FLORIDA DEPARTMENT OF Environmental Protection

NOTICE TO APPLICANTS ADDENDUM NO. TWO (2)

Big Lagoon State Park – Boat Ramp Area Improvements DEP BID NO. BDC25-18/19

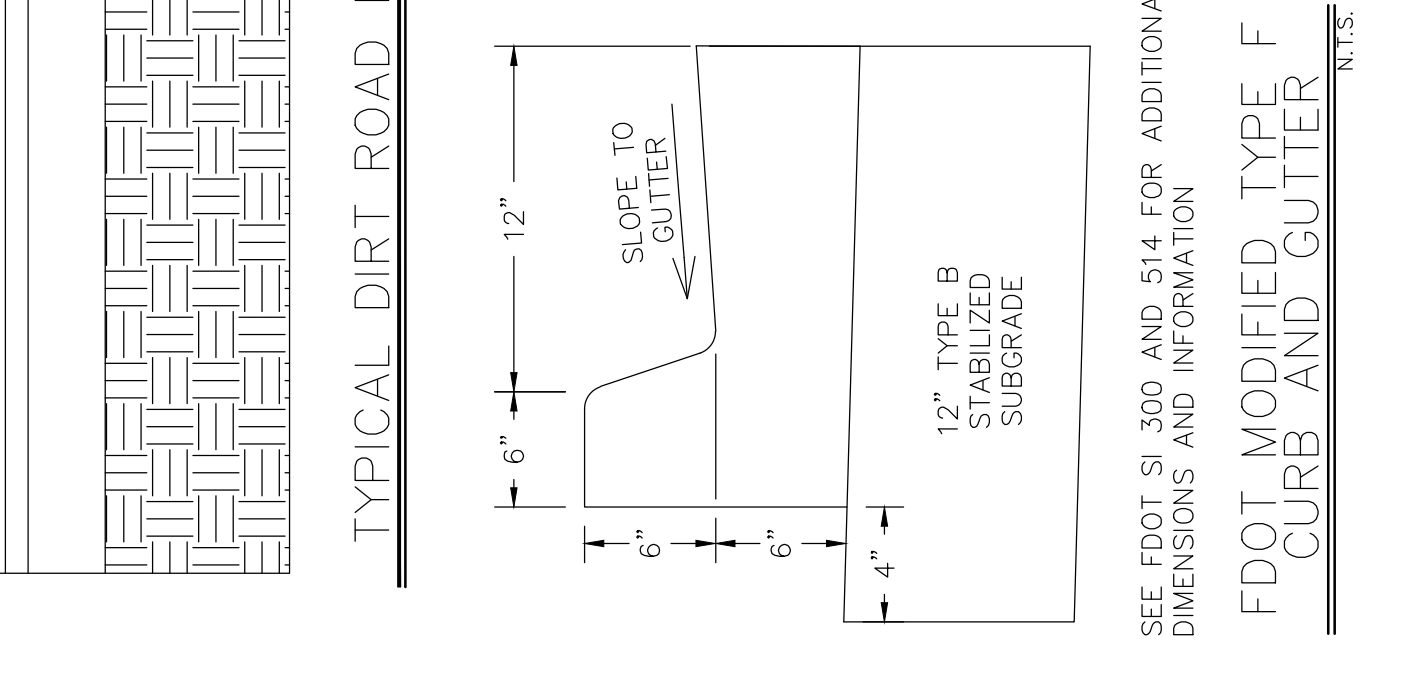
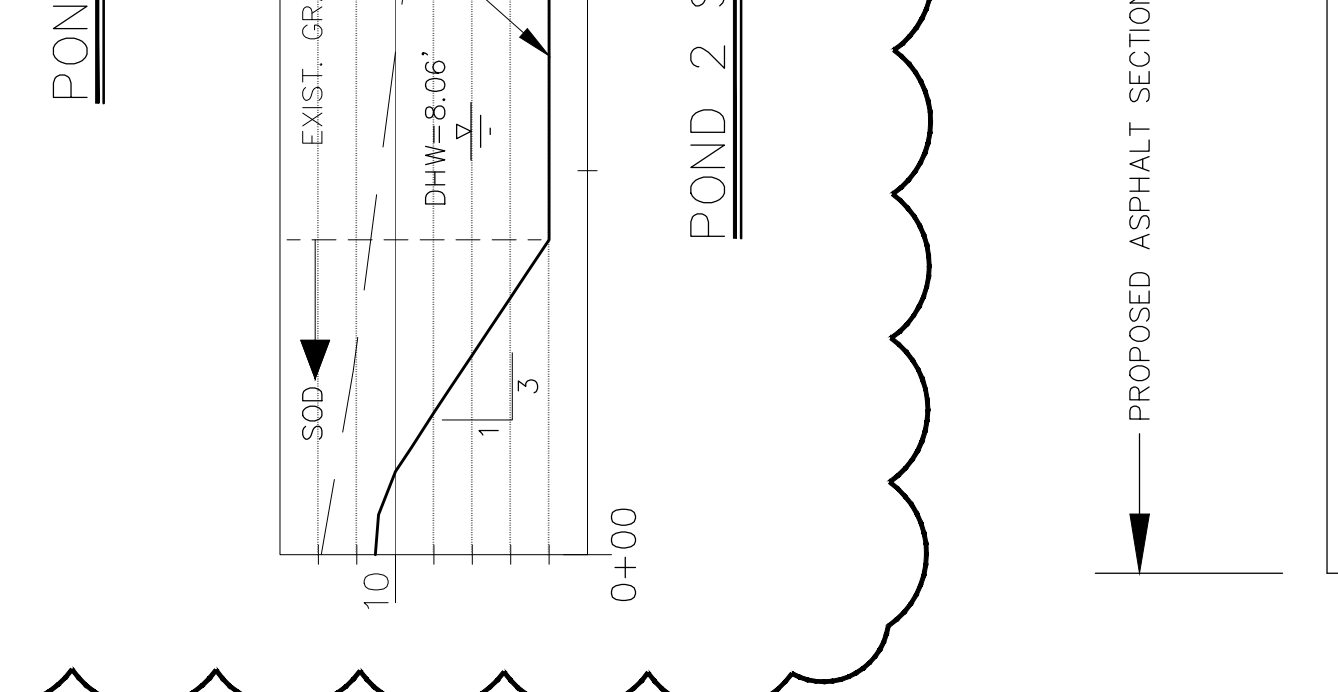
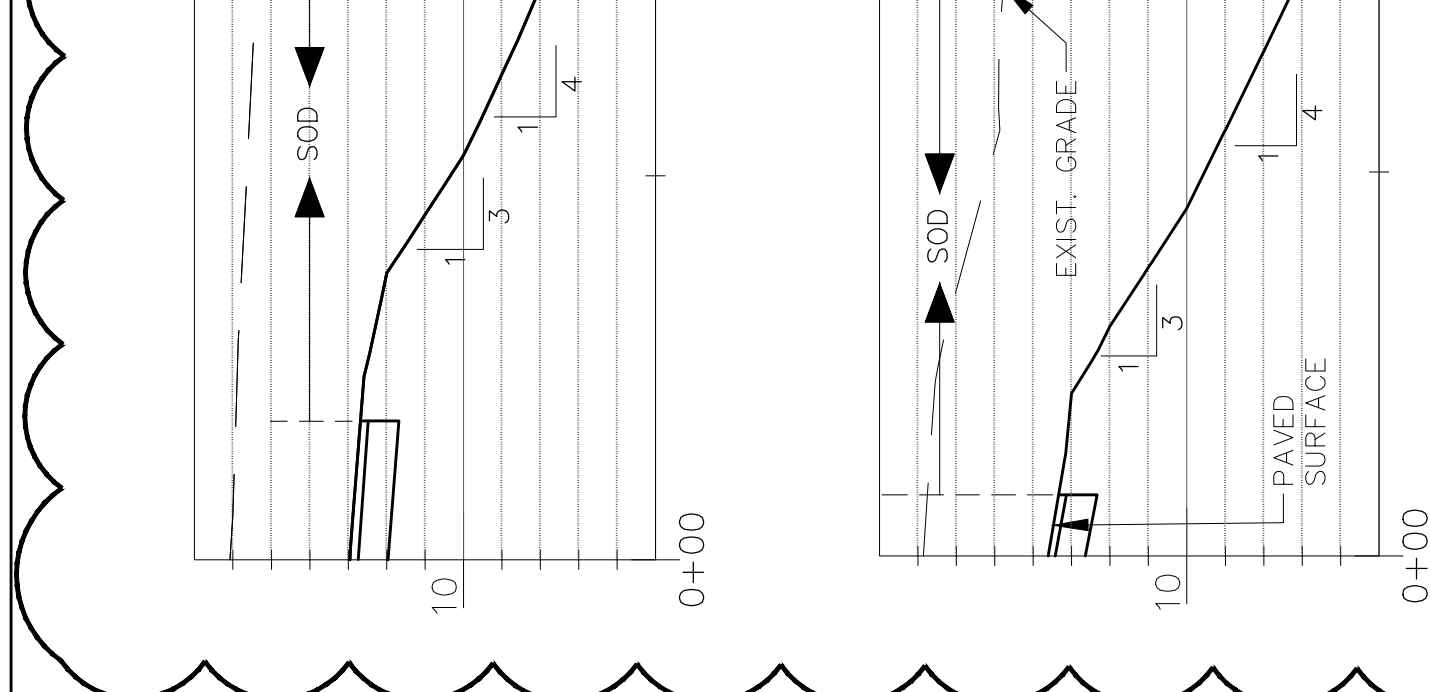
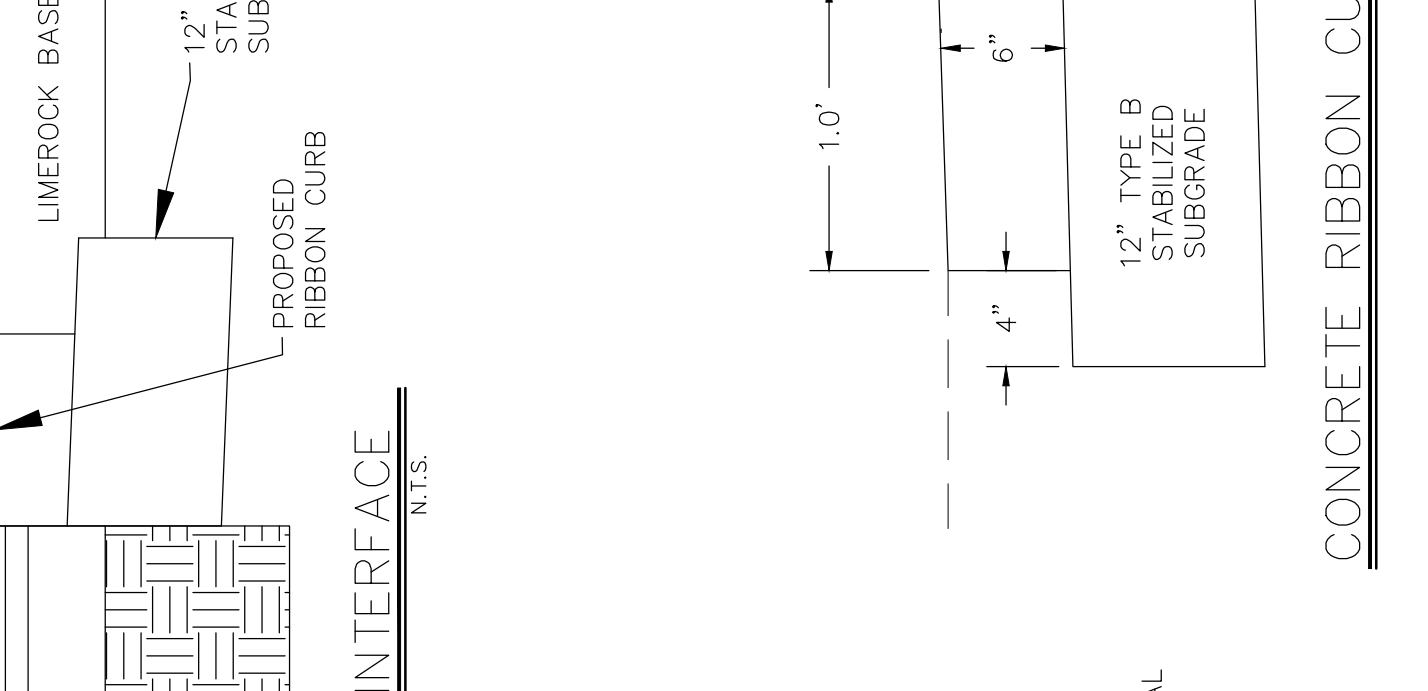
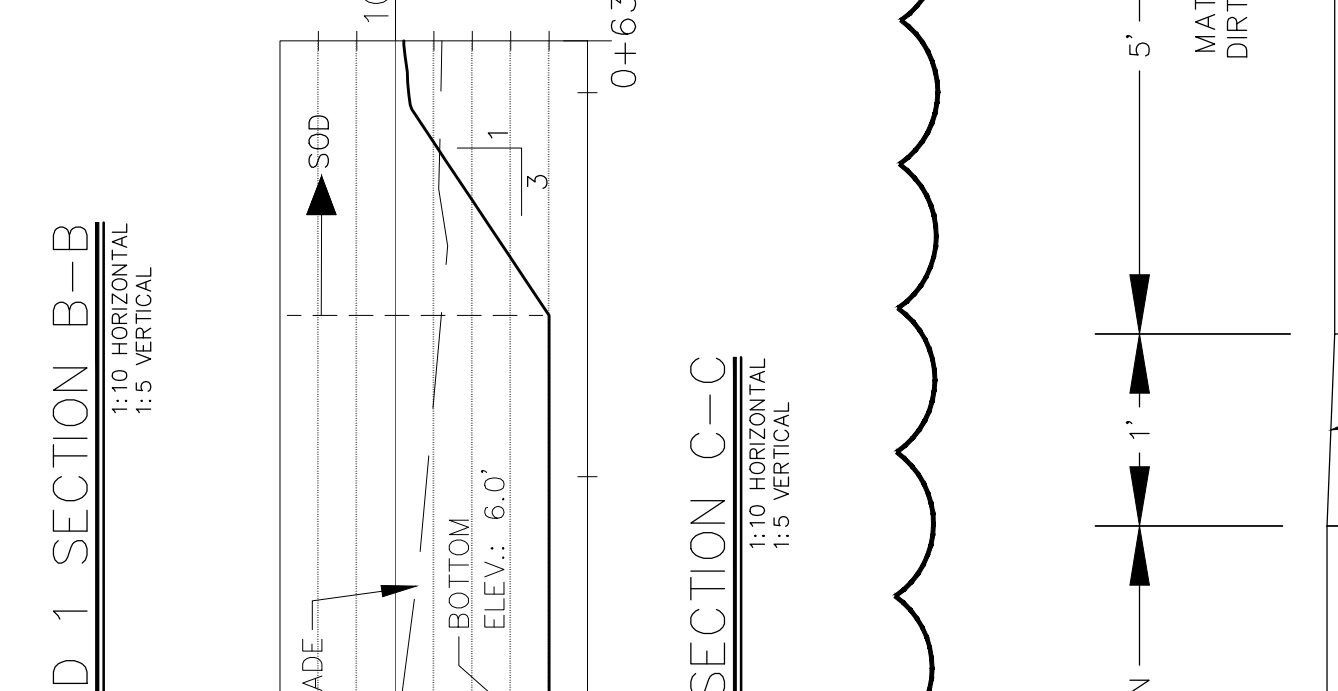
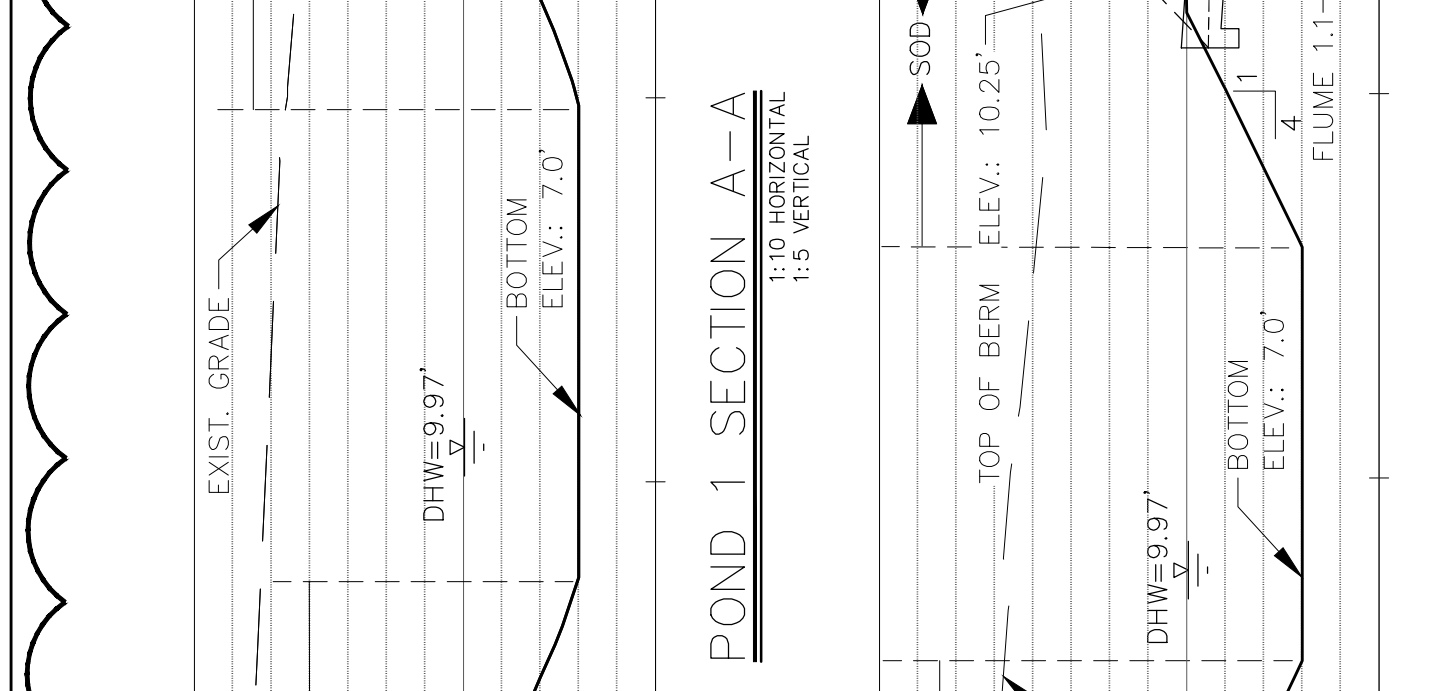
12. Question: Sheet C106 of the construction plans illustrates a cofferdam is not allowed for ramp construction. Can someone illustrate on this? A steel sheet pile cofferdam is a preferred method to construct the boat ramp.

Answer: A push-in / no-dewatering methodology is required per the U.S. Army Corps of Engineers permit. This is a common construction technique. Upland portions of the ramp may be cast in place, however, precast slab will be pushed in for the ramp. FDEP will provide personnel to verify final subgrades in a timely manner that will be agreed prior to contract execution. This will require close coordination between the Contractor and FDEP.
